SUBJECT: Forwards proposed changes to FSAR Sections 1.9, 2.4, 6.3, 1.4, 15.1.5 & app 15C incorporating results of main steam line break analyses. Changes will be incorporated into next FSAR amend per NRC approval.

Subject: Palo Verde Nuclear Generating Station (PVNGS)  
Units 1, 2, and 3  
Docket Nos. STN 50-528(License No. NPF-41)/529/530  
Main Steam Line Break Analyses Results - Chapter 15 Reanalyses  
File: 85-056-026; G.1.01.10

The results are presented as proposed changes to FSAR Sections 1.9.2.4, 6.3.1.4, 15.1.5 and Appendix 15C and are all within NRC acceptance criteria. Upon NRC approval, these FSAR changes will be incorporated into the next PVNGS FSAR Amendment.

Figure 15.1.1-1

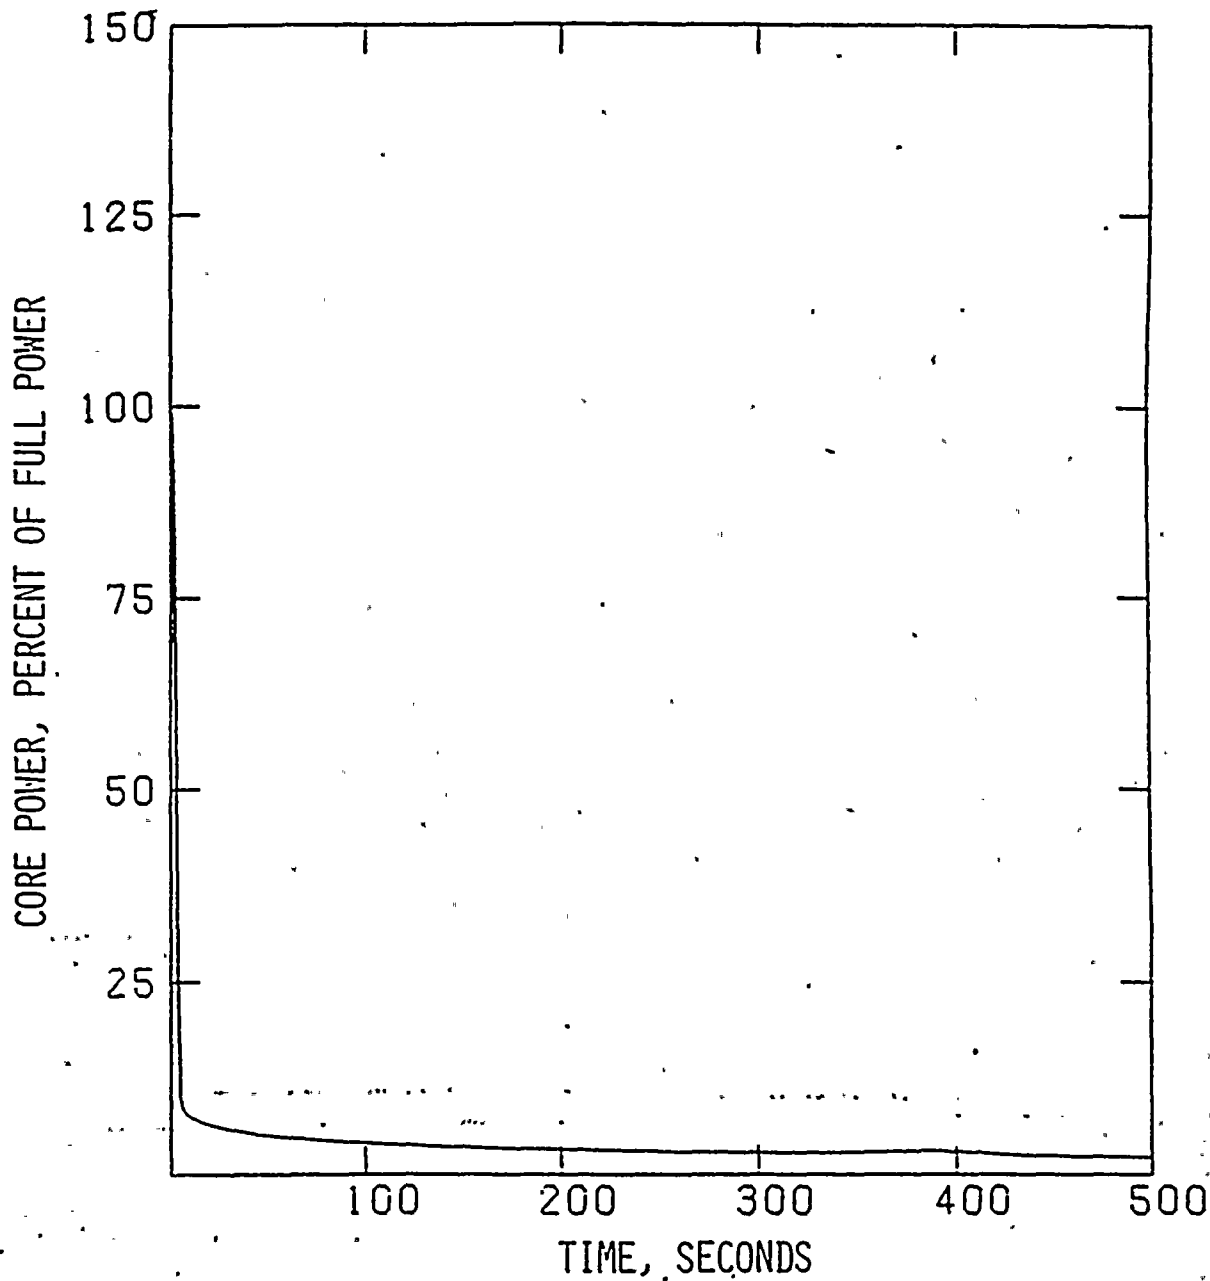
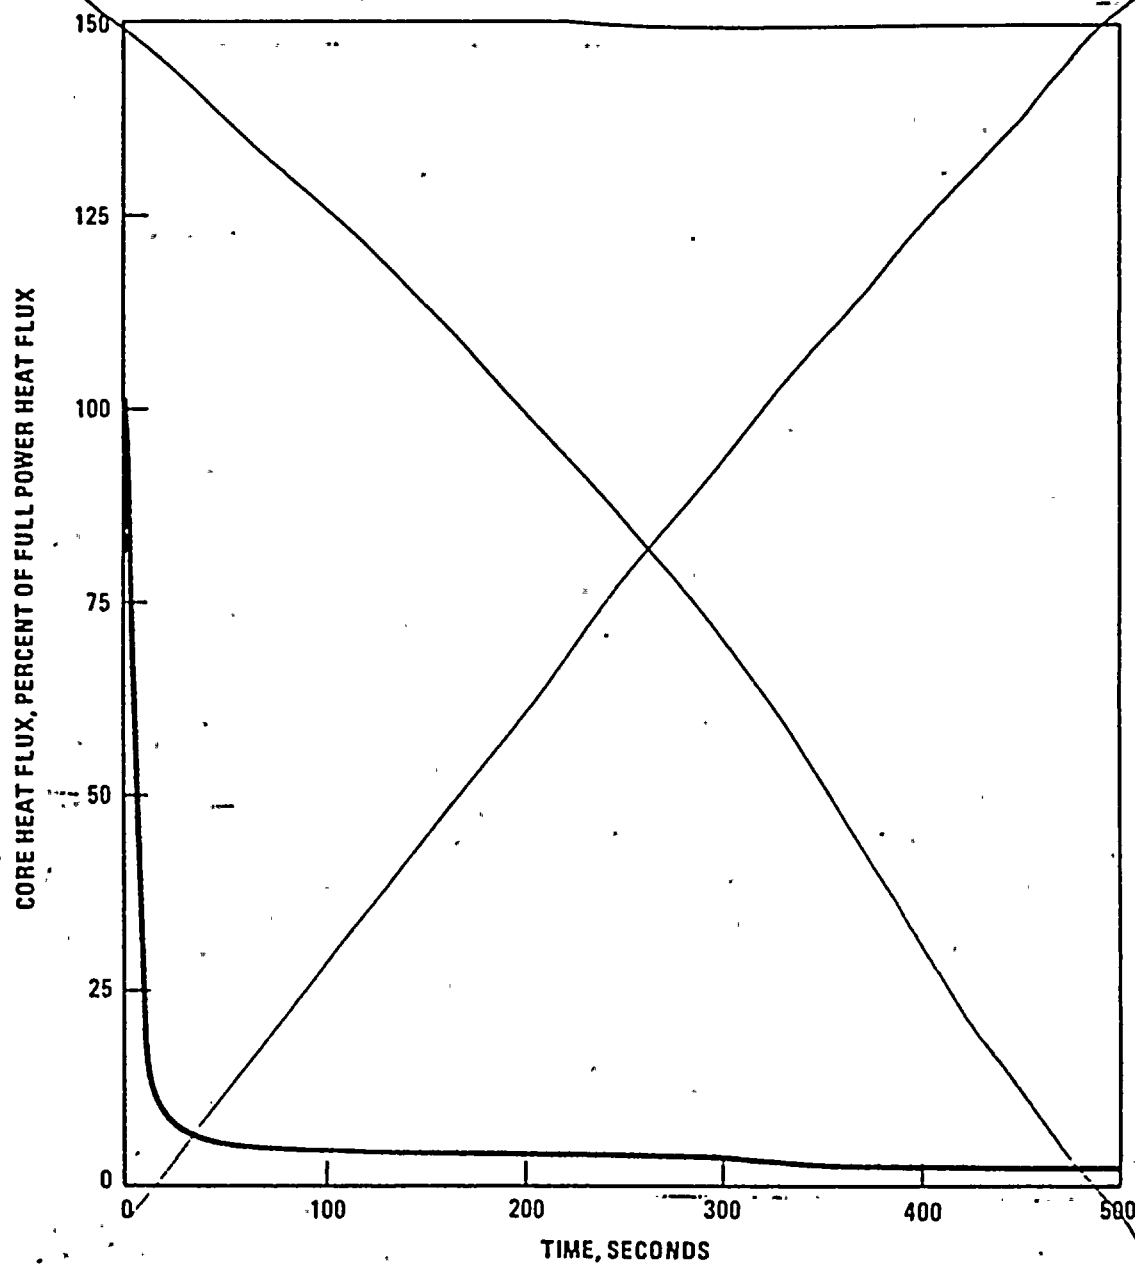
Replace with Figure 15.1.1-2

FULL POWER LARGE STEAM LINE BREAK WITH  
CONCURRENT LOSS OF OFFSITE POWER  
RCS PRESSURE VS TIME  
Figure 15.1.1-3

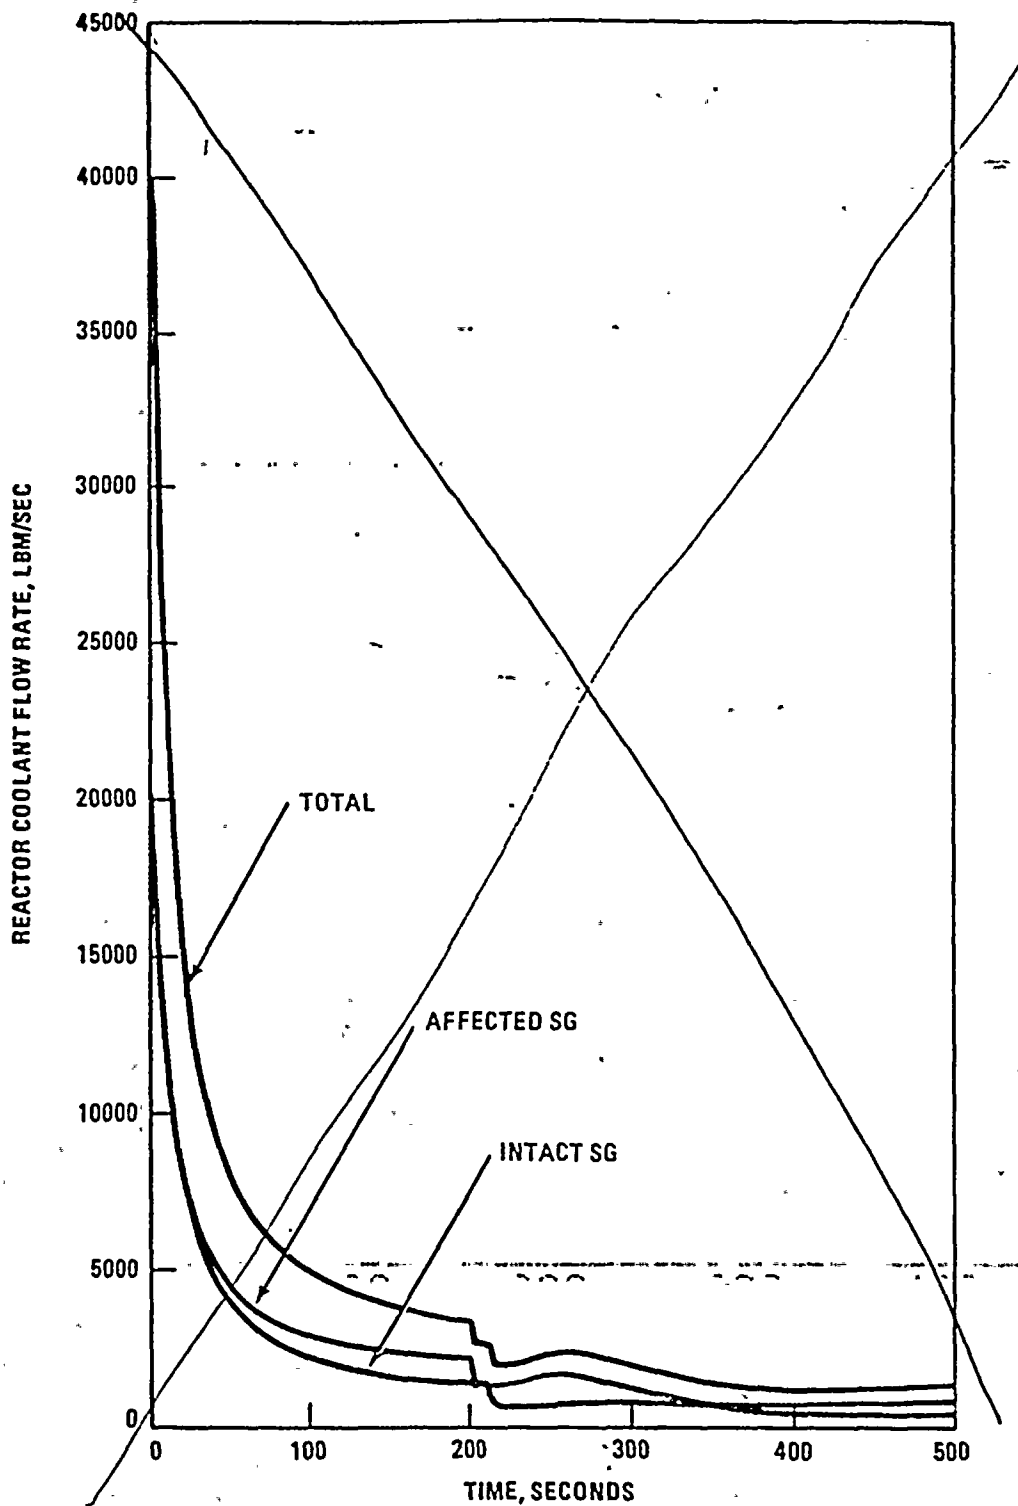
Replace with Figure 15.1.1-4

Figure 15.1.1-4

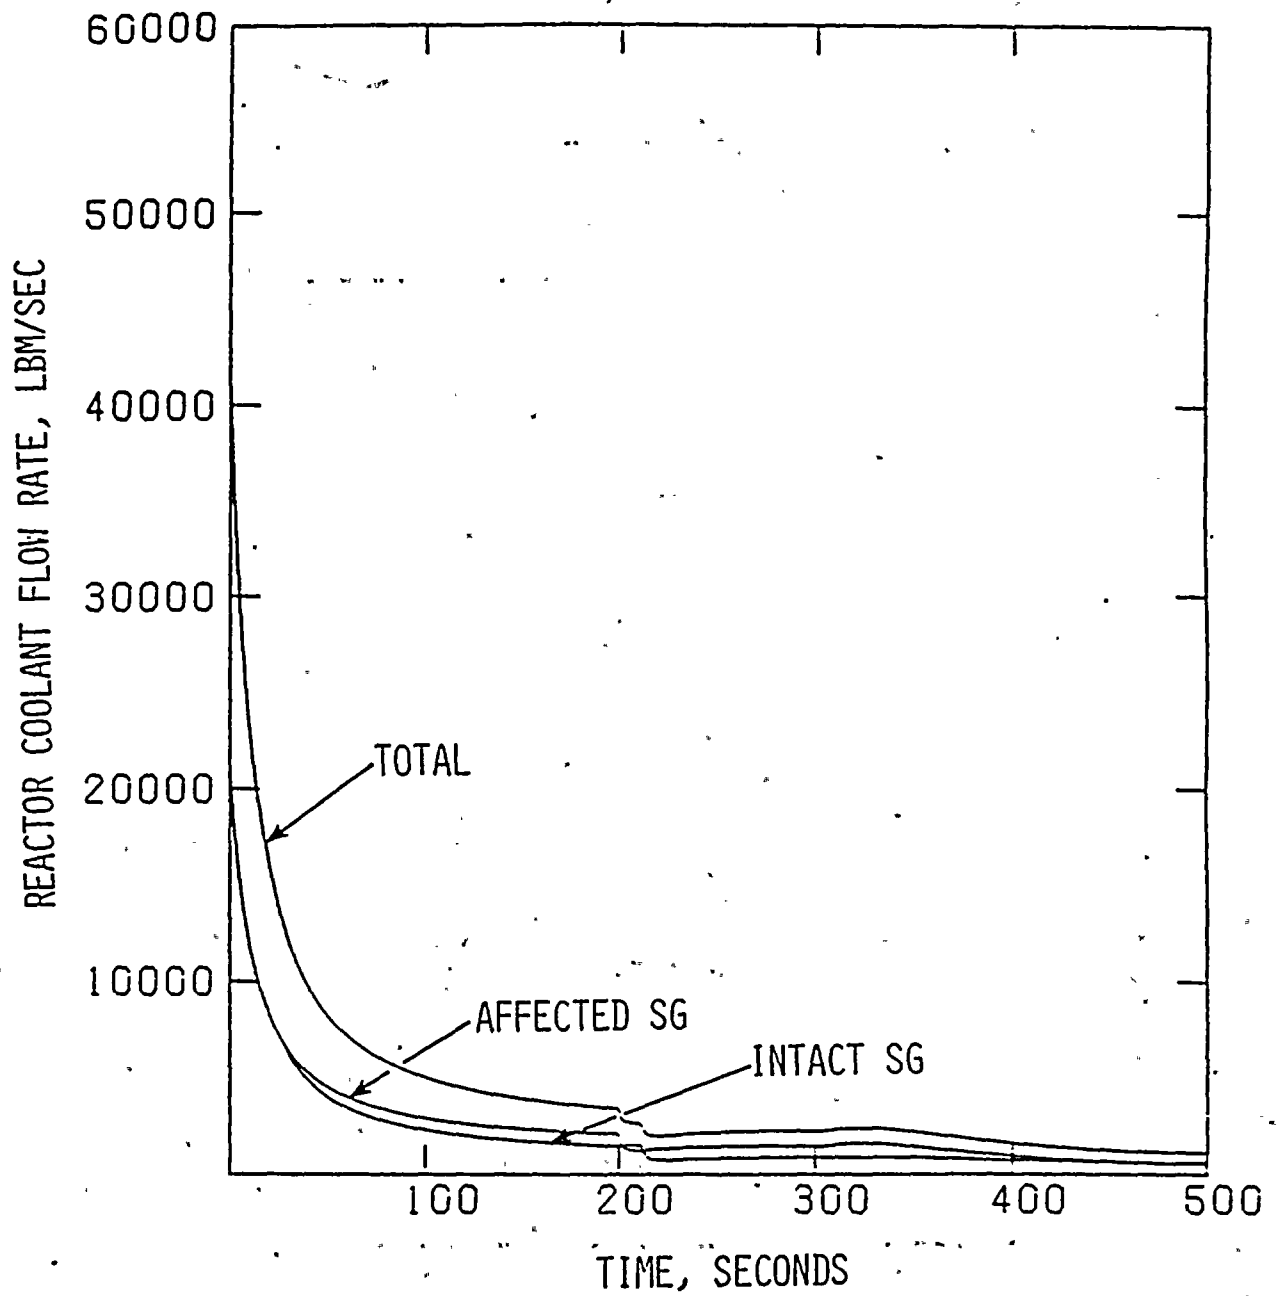
Replace with Figure 15.1.1-5

Figure 15.1.1-5

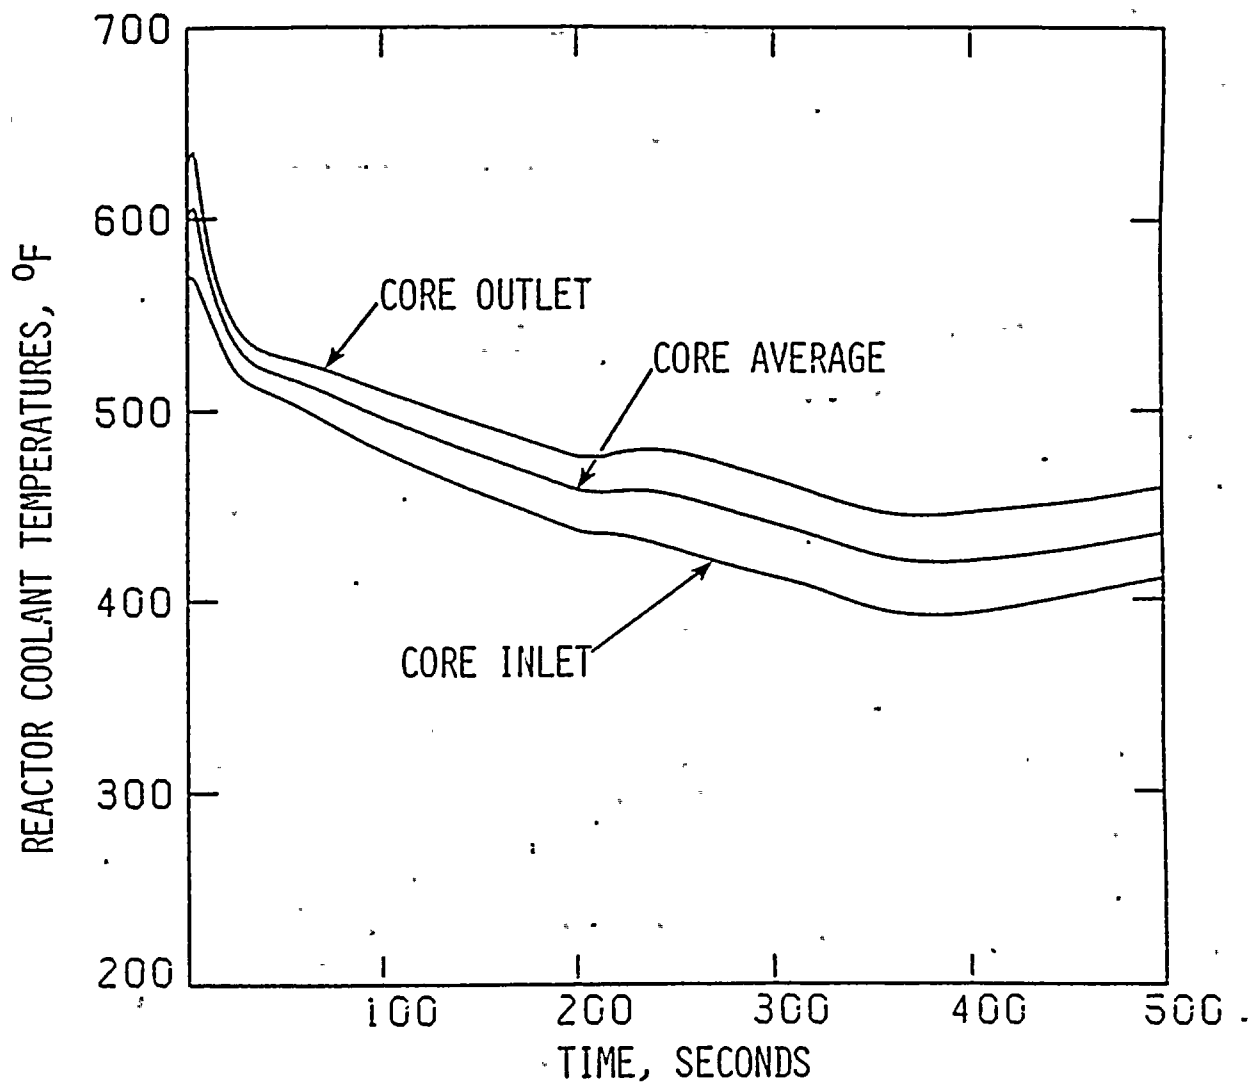
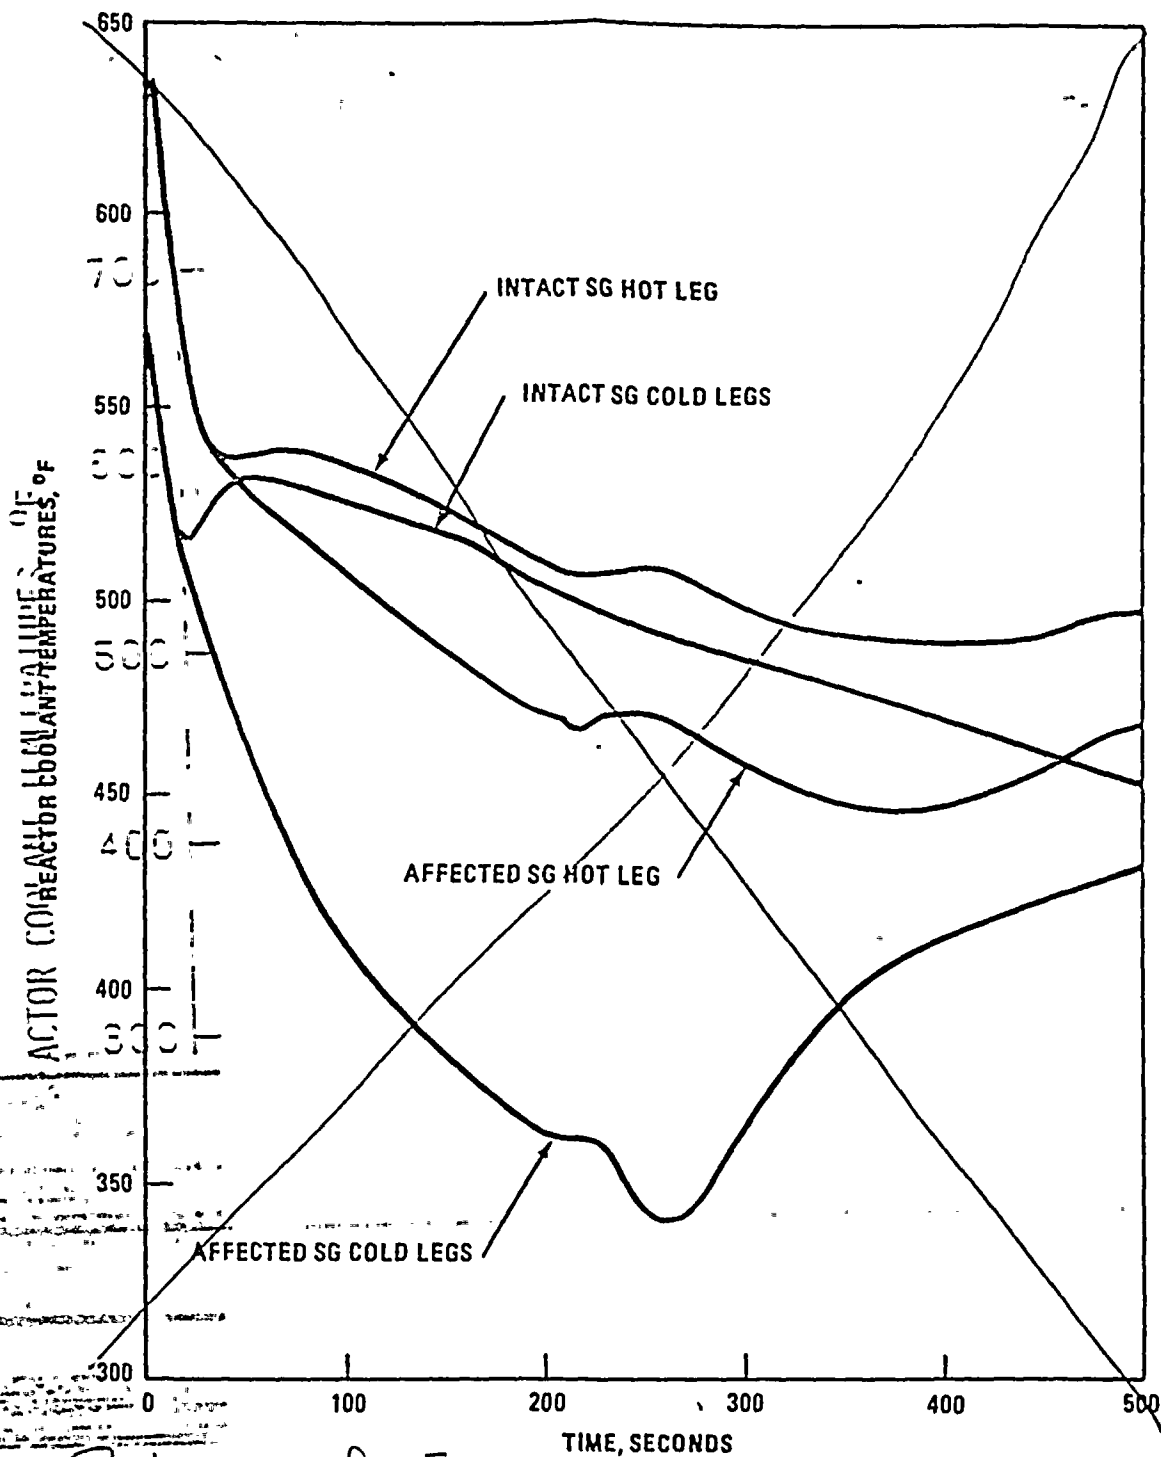
Replace with Figure 15.1.1-6
